October 14, 2005

The NEMA Lamp Section submits the following written comments in response to the Department of Energy's Energy Star Program request for stakeholder input on the draft revisions to the CFL Energy Star specification dated August 30, 2005.

Proposed LPW Limits for Bare, Non-dimmable CFL Lamps

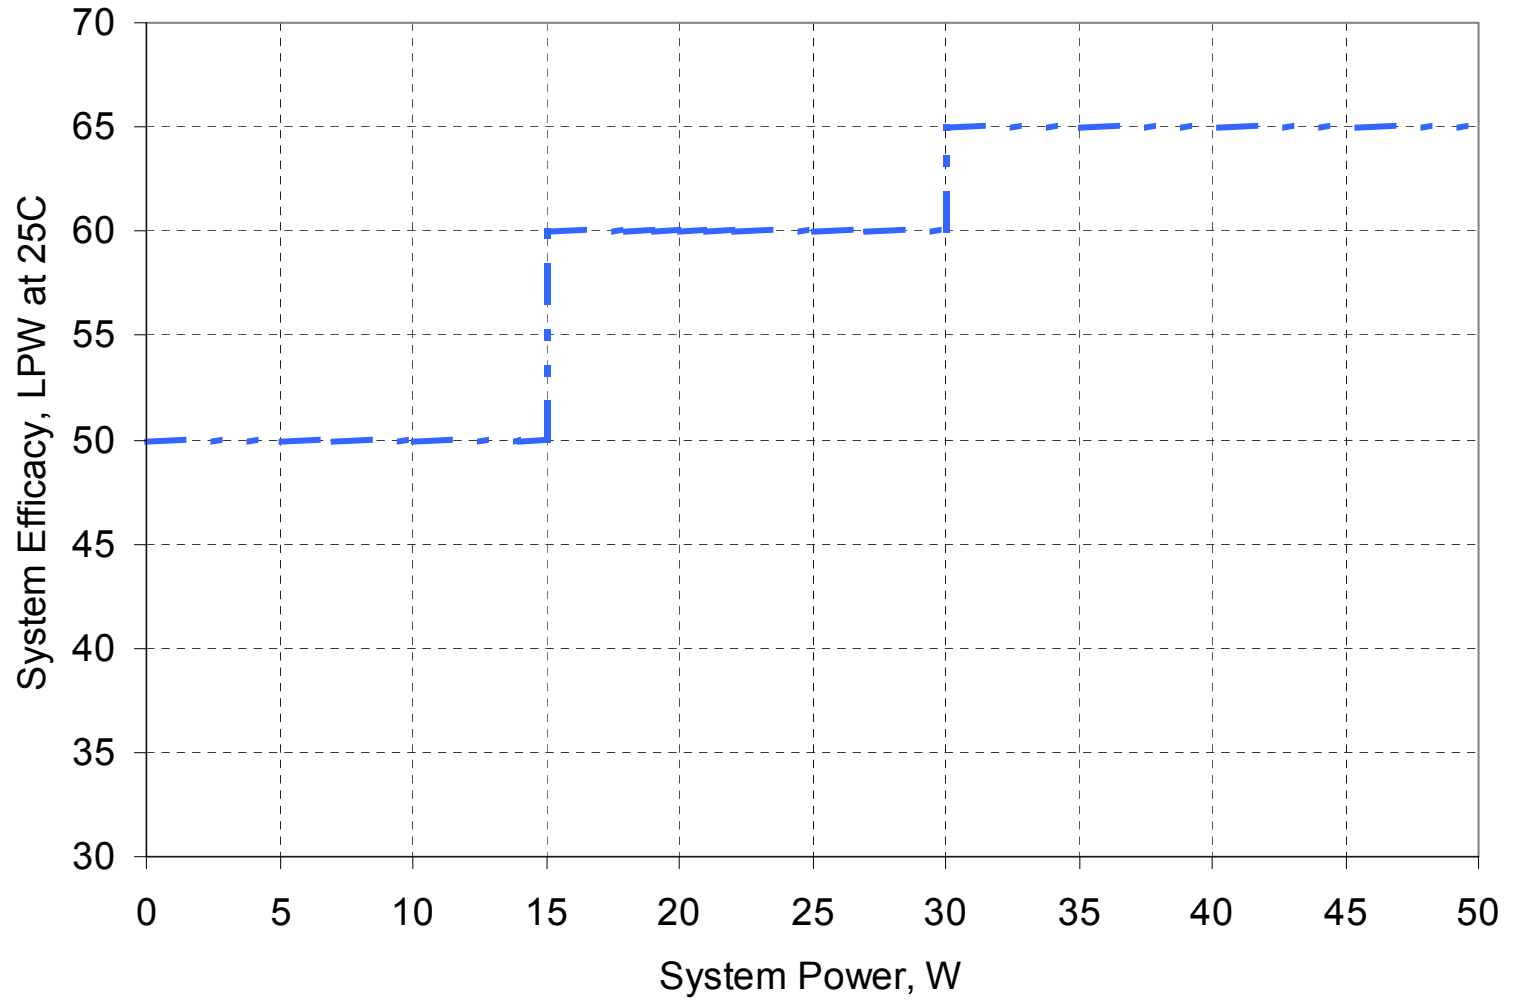
For all of the above reasons, we think that the proposed specification makes too big a leap in efficacies. As an alternative to the August 30th proposed levels, we propose the following, for non-dimmable, non-reflector bare and covered lamps:

The graph included at the end of these comments also shows these proposed levels.

Lamp Power (Watts) and Configuration	Minimum Efficacy: Lumens/watt
Bare Lamp	
Lamp Power < 15W	50.0
15W = Lamp Power < 30W	60.0
Lamp Power = 30W	65.0
Covered Lamp	
Lamp Power < 15W	45.0
15W = Lamp power < 19W	48.0
19W = Lamp Power < 25W	50.0
Lamp Power = 25	55.0
